MARKHAM ST. JUMP START IMPVTS. (CONWAY) (S) F.A.P. STPU-9095(33) ARDOT JOB 080566

MARKHAM ST. JUMP START IMPVTS.
(CONWAY) (S)

REV.	DATE	DESCRIPTION
Δ	10/14/2019	CHANGE ORDER NO. 1 - REVISE INDEX OF SHEETS

TEMPORARY EROSION CONTROL PLAN

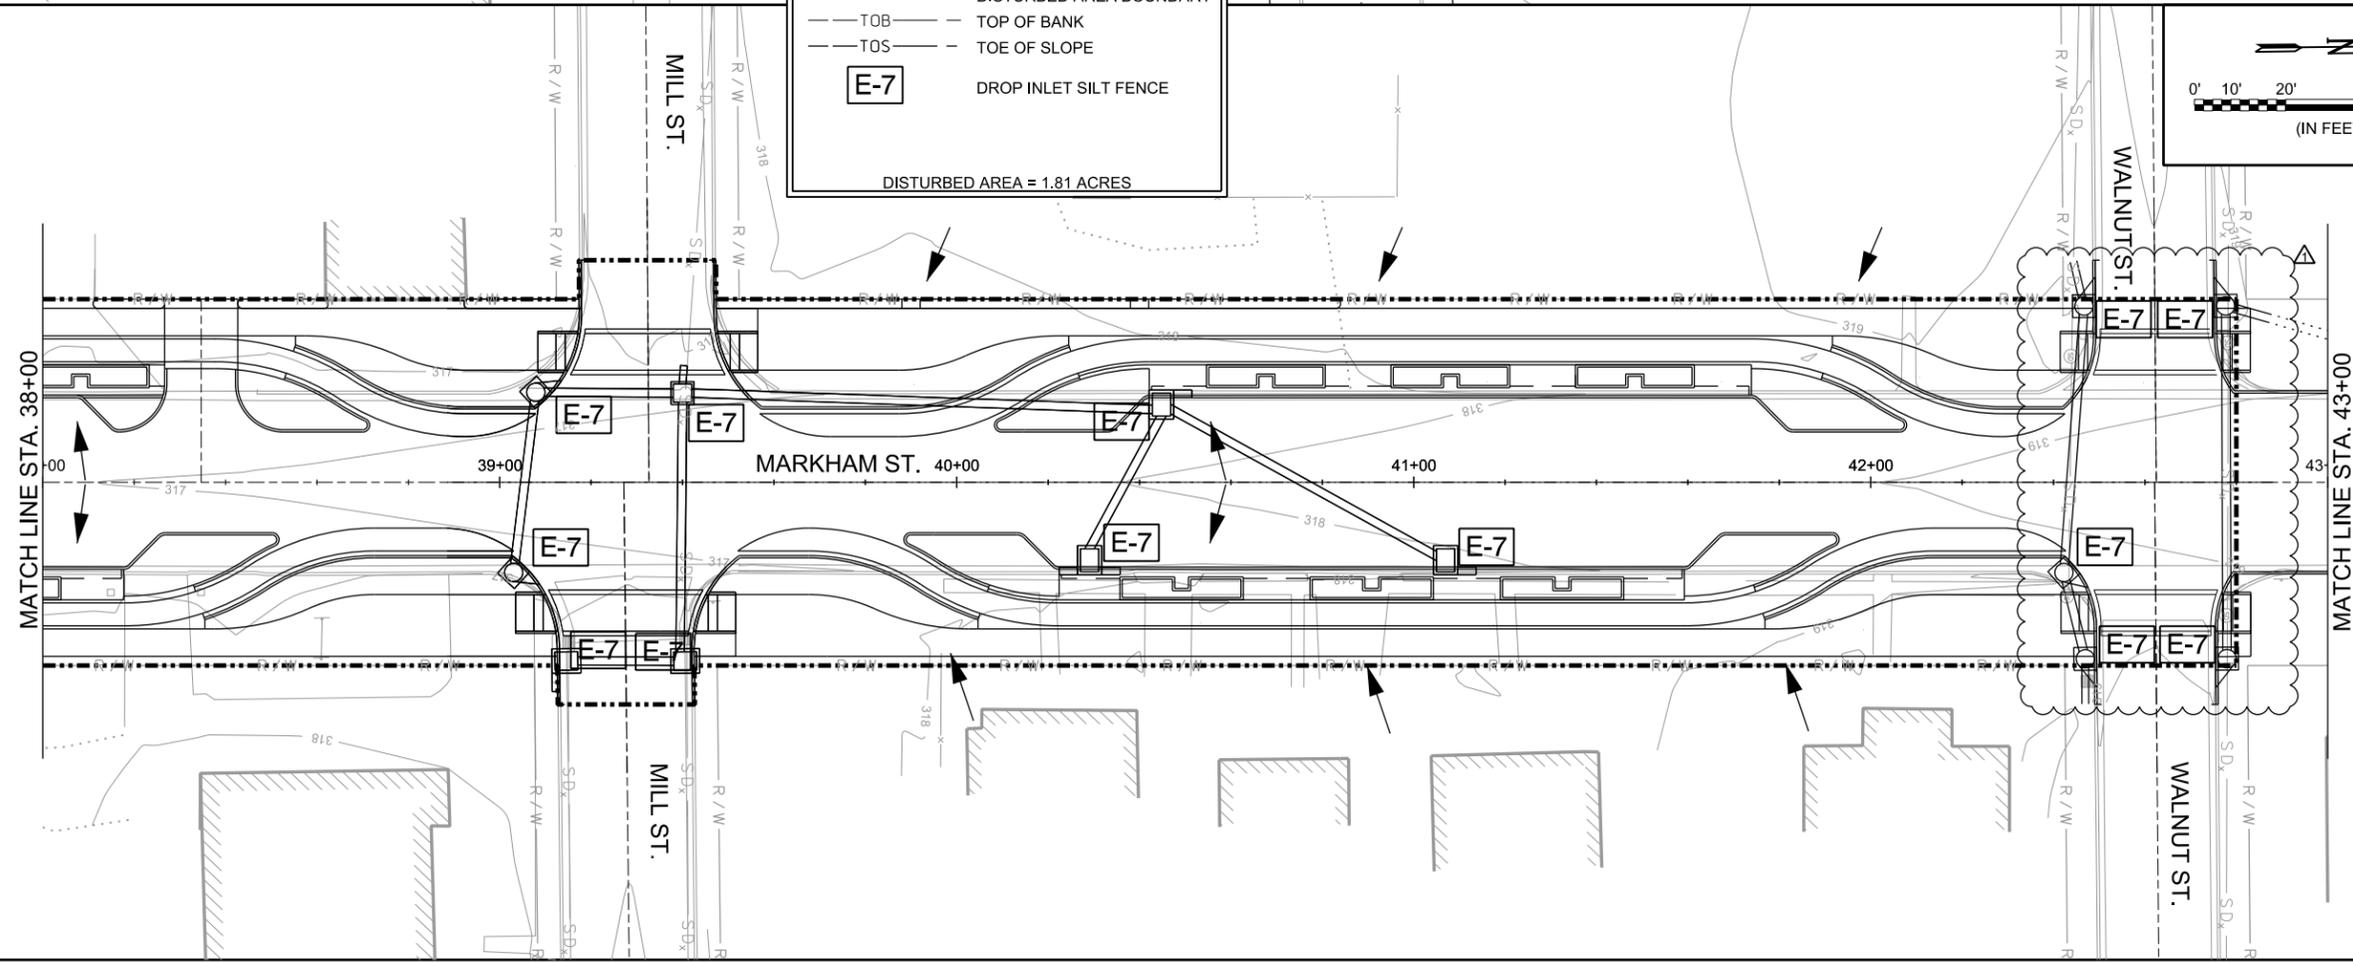
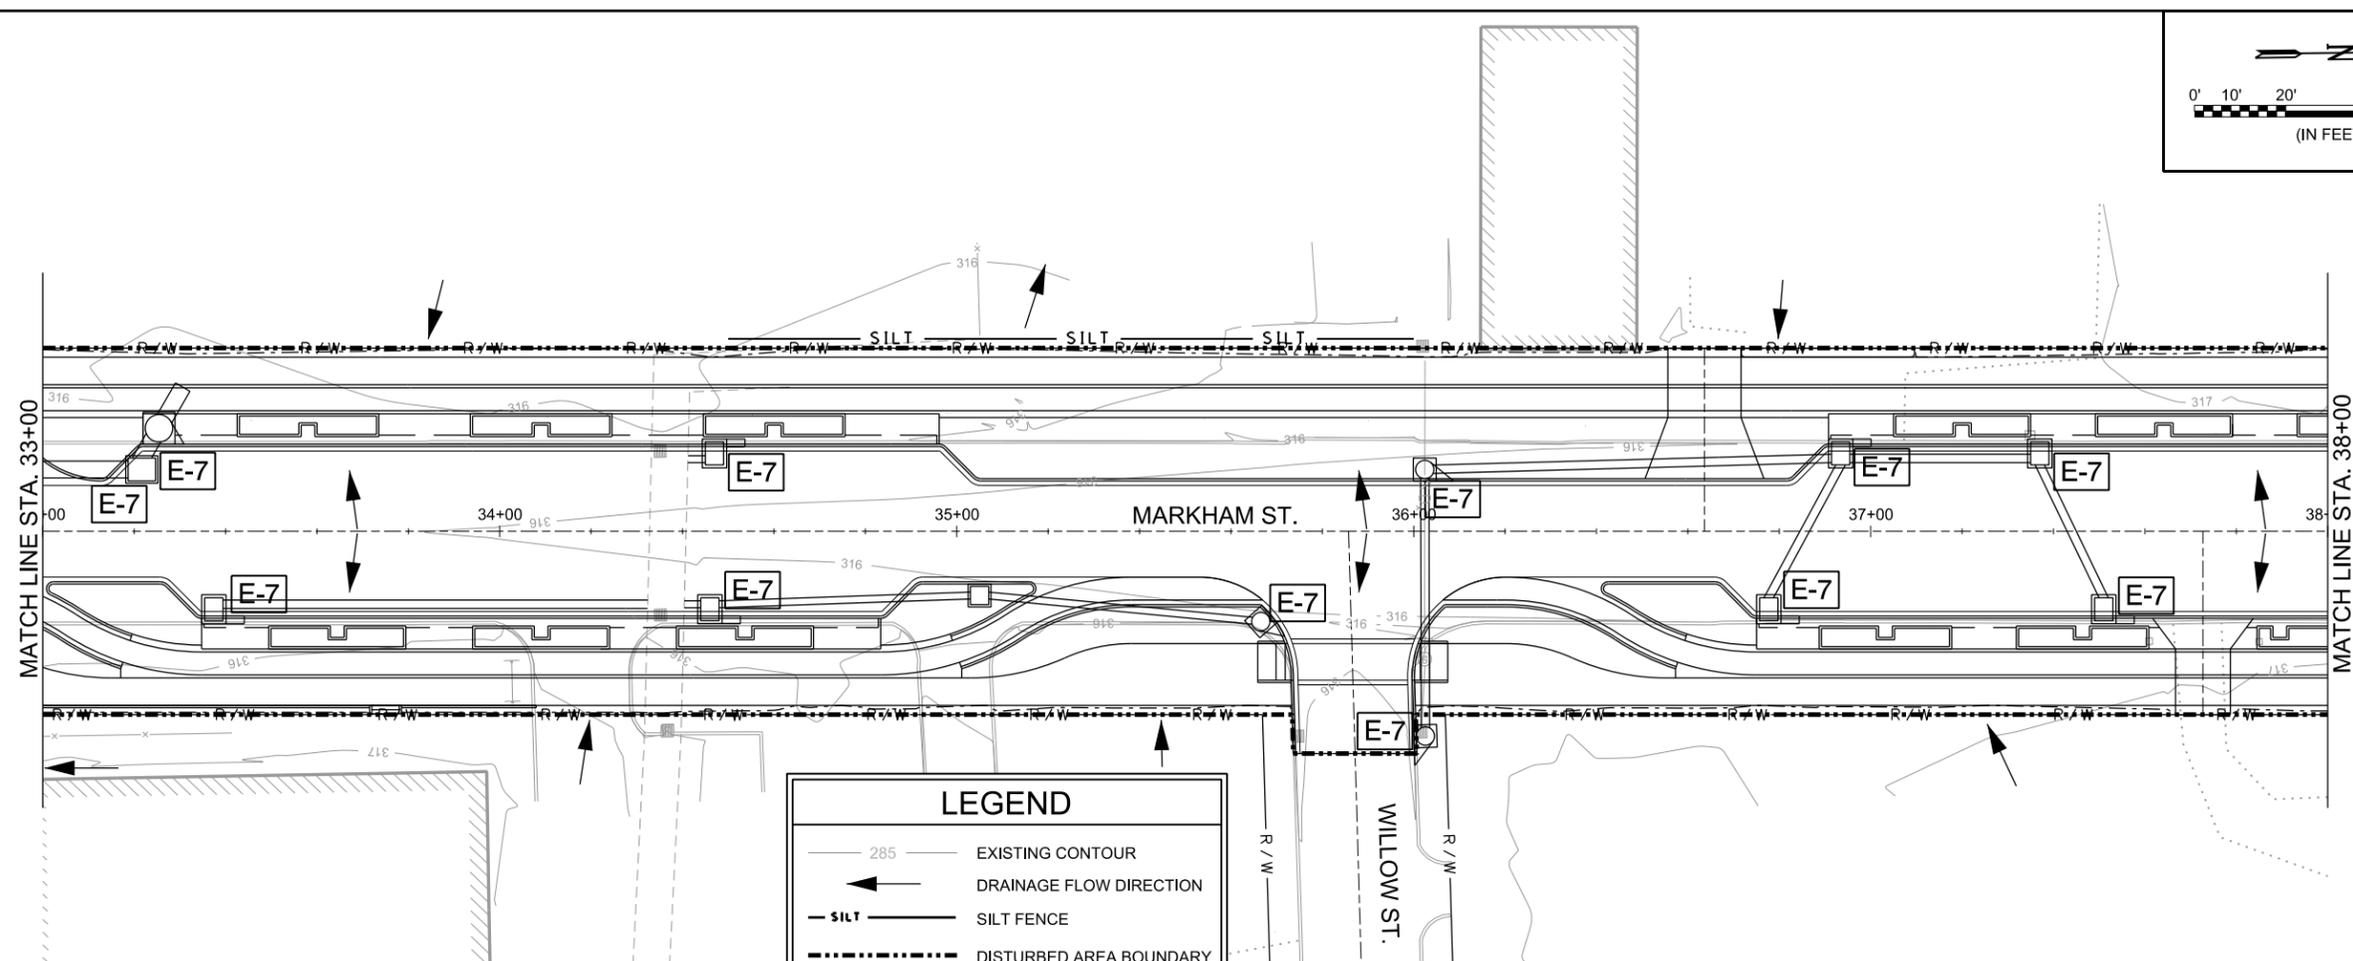
REV.	Δ		
DATE	10/14/2019		
DESCRIPTION	CHANGE ORDER NO. 1 - ADD EROSION CONTROL DEVICES AT WALNUT		
BY	DLT

PLAN AND PROFILE - MARKHAM ST.
(SHEET 1 OF 6)

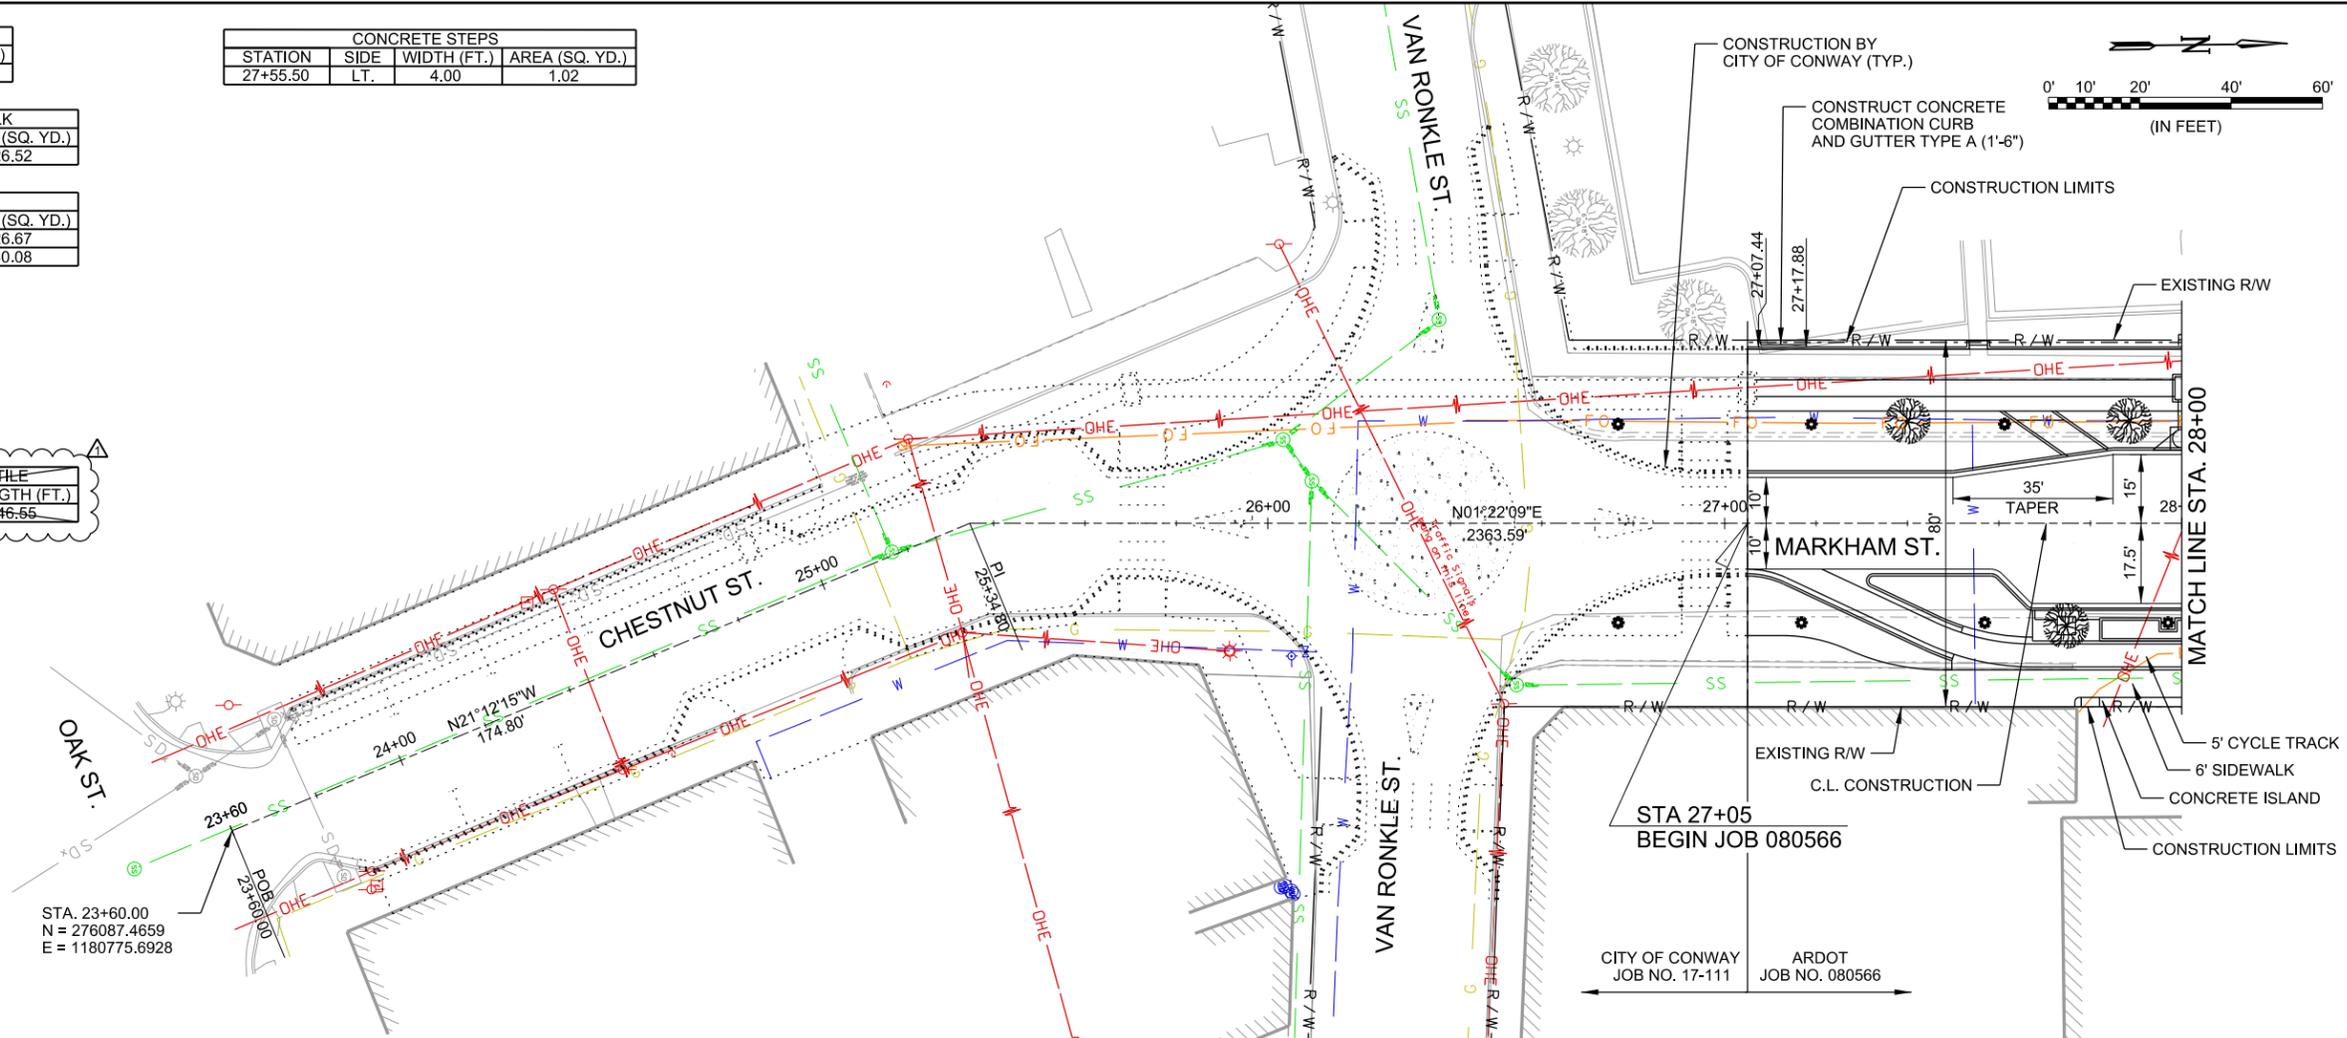
REV.	DATE	DESCRIPTION
Δ	10/14/2019	CHANGE ORDER NO. 1 - REMOVE DETECTABLE DIRECTIONAL BAR TILE

PLAN AND PROFILE - MARKHAM ST.
(SHEET 2 OF 6)

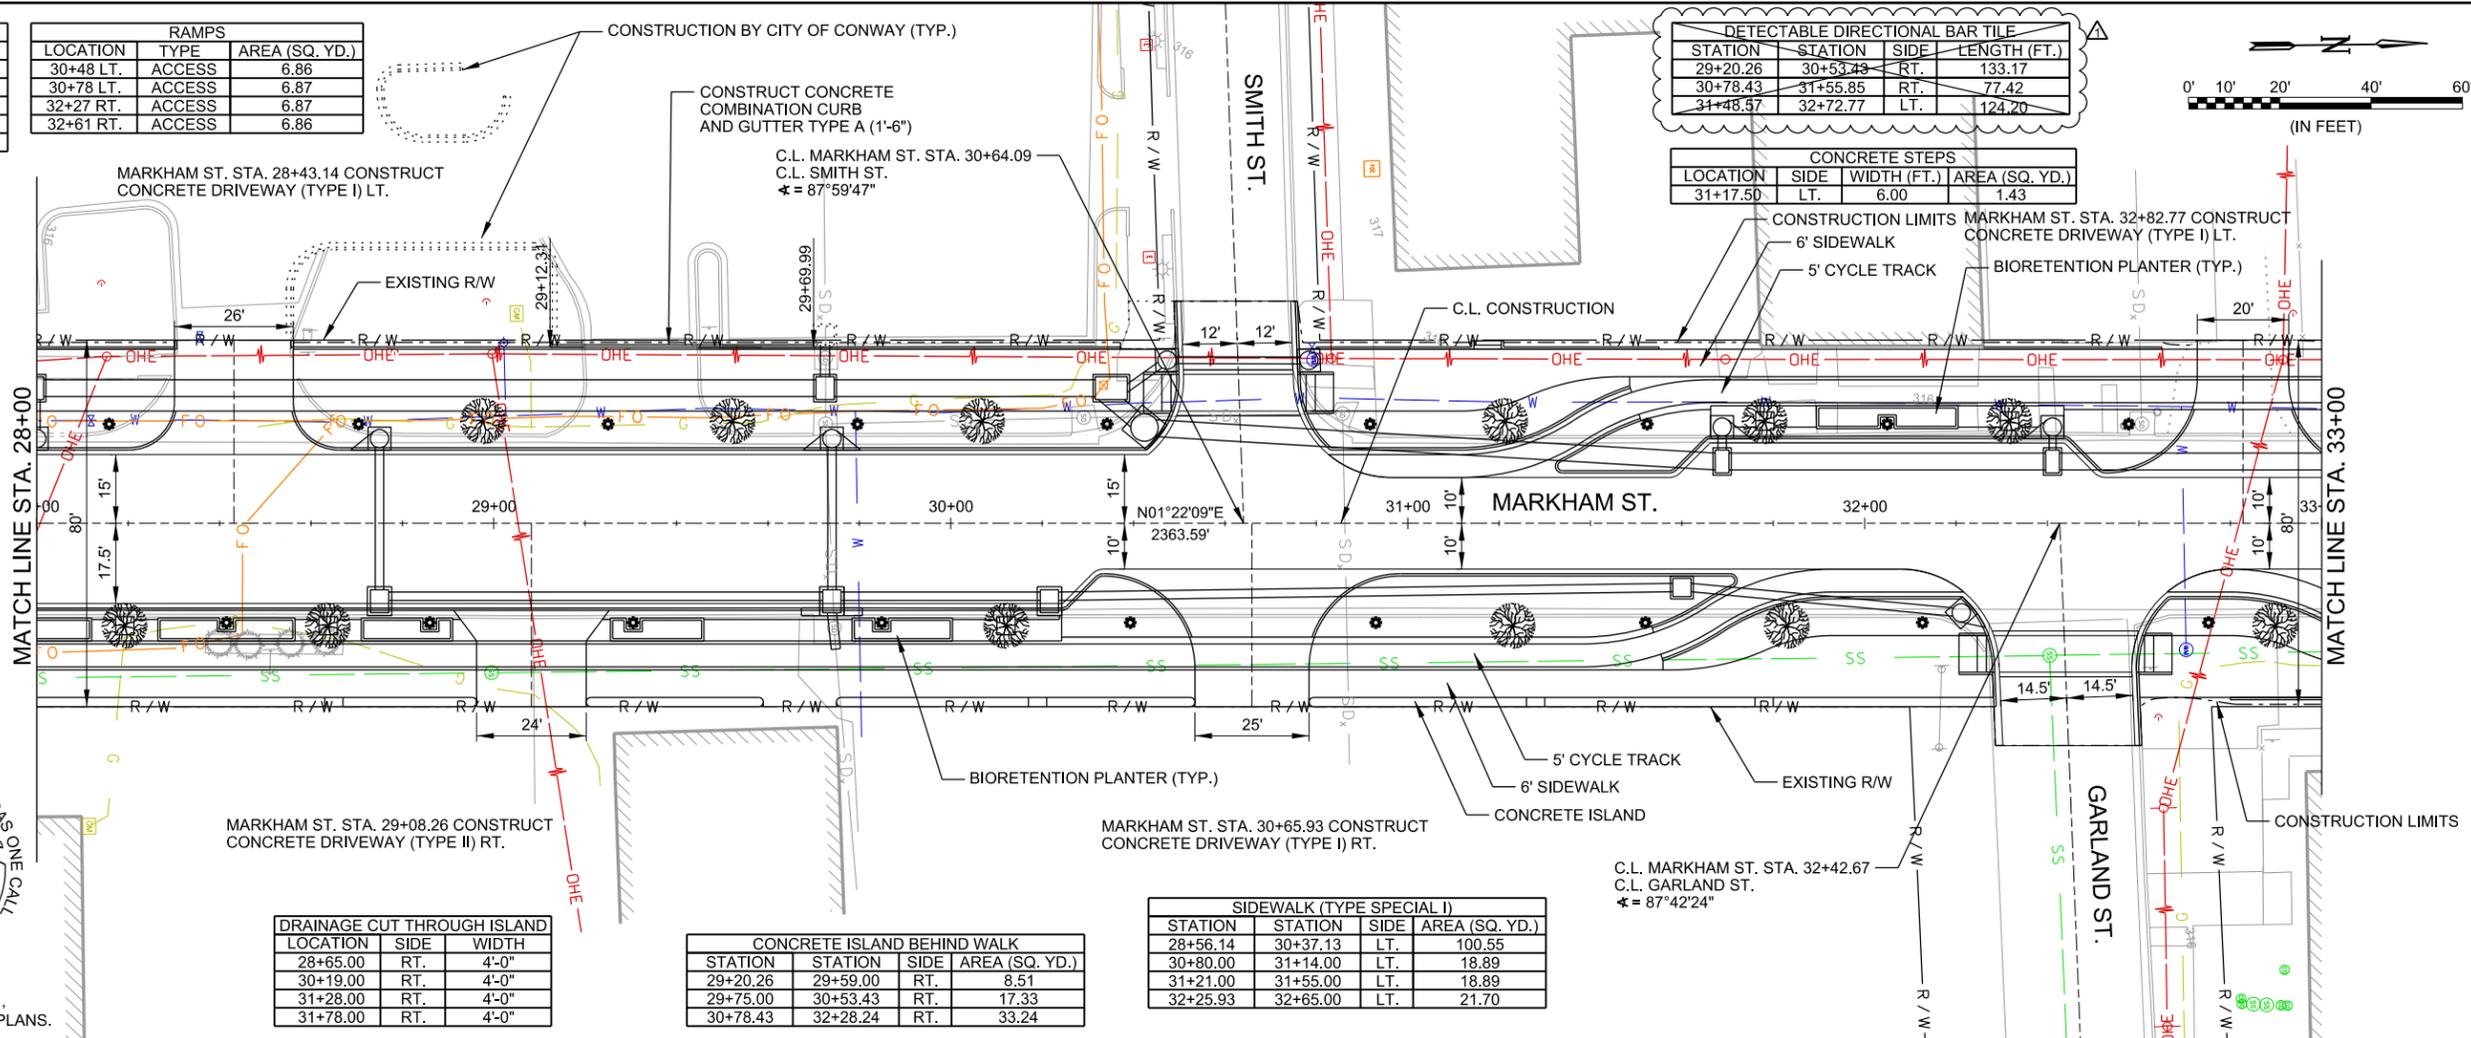
REV.	DATE	DESCRIPTION
1	10/14/2019	CHANGE ORDER NO. 1 - REMOVE DETECTABLE DIRECTIONAL BAR TILE

PLAN AND PROFILE - MARKHAM ST.
 (SHEET 3 OF 6)

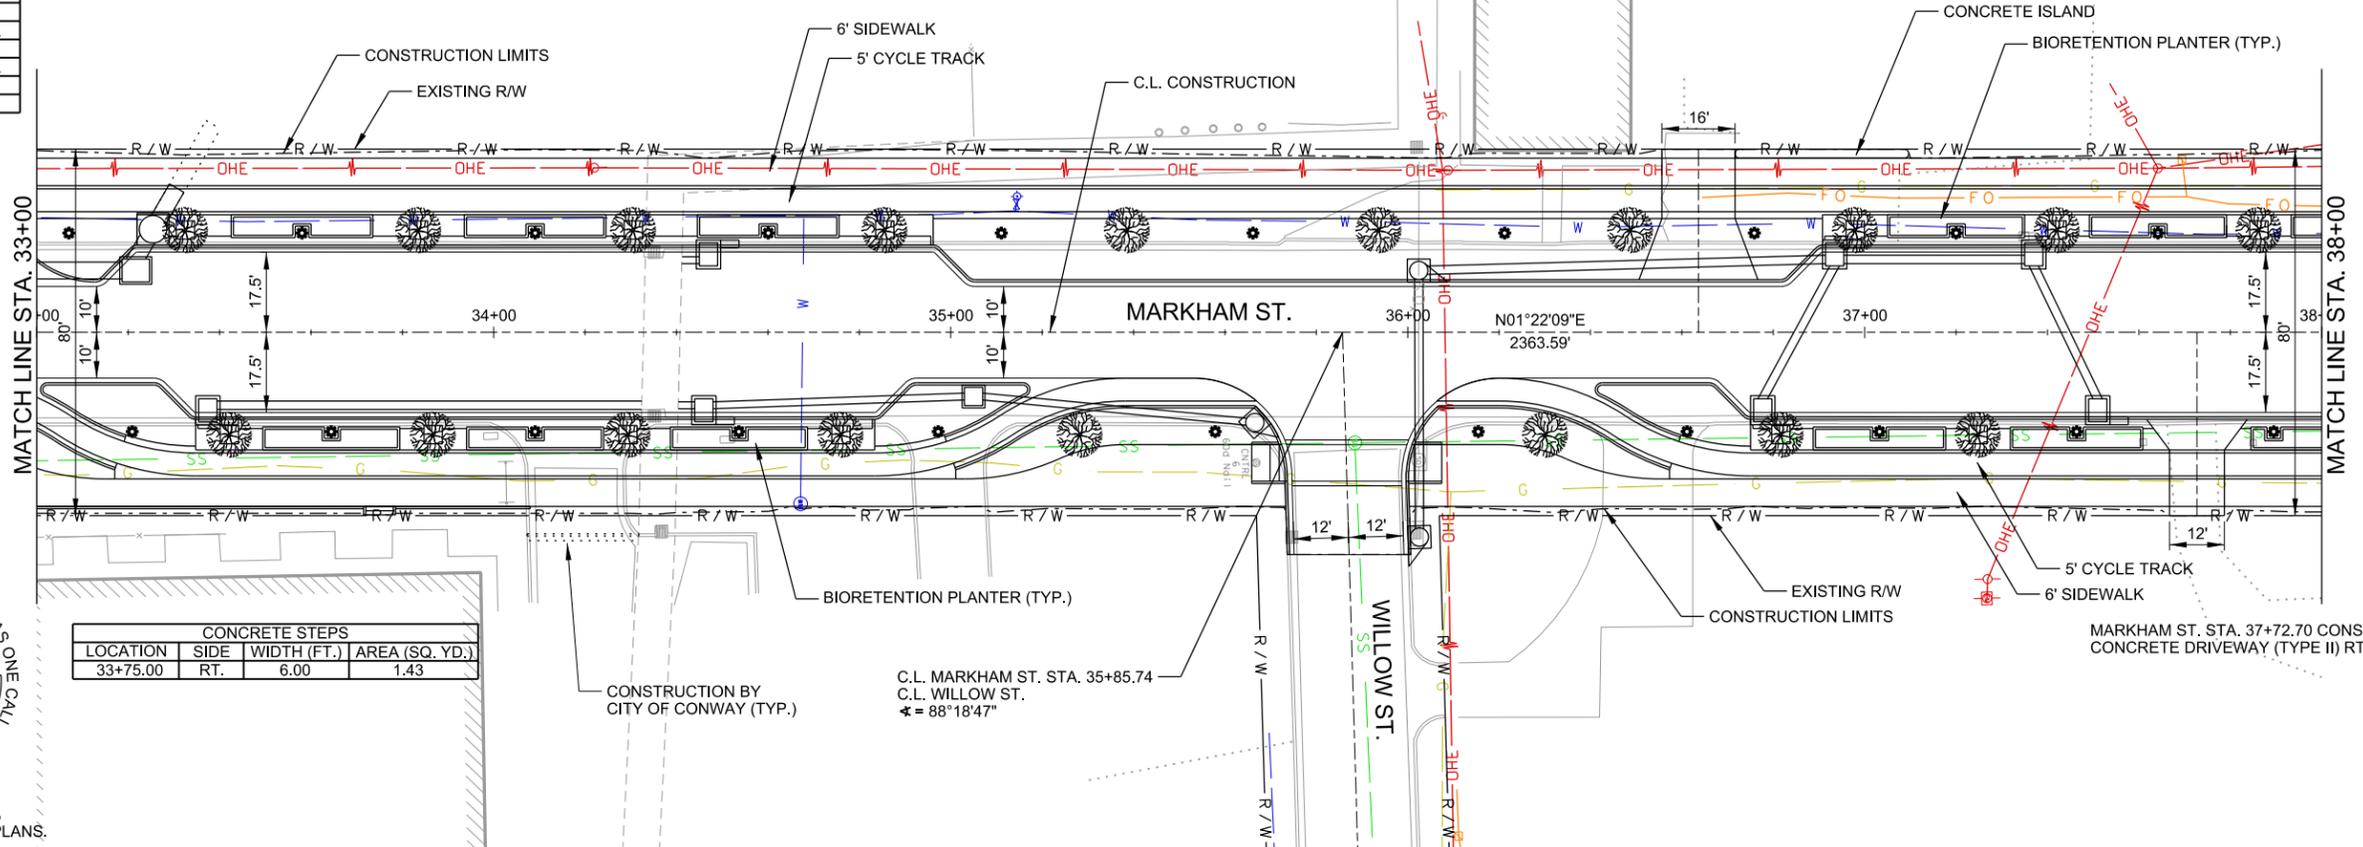
REV.	DATE	DESCRIPTION	BY
Δ	10/14/2019	CHANGE ORDER NO. 1 - REMOVE DETECTABLE DIRECTIONAL BAR TILE	DLT
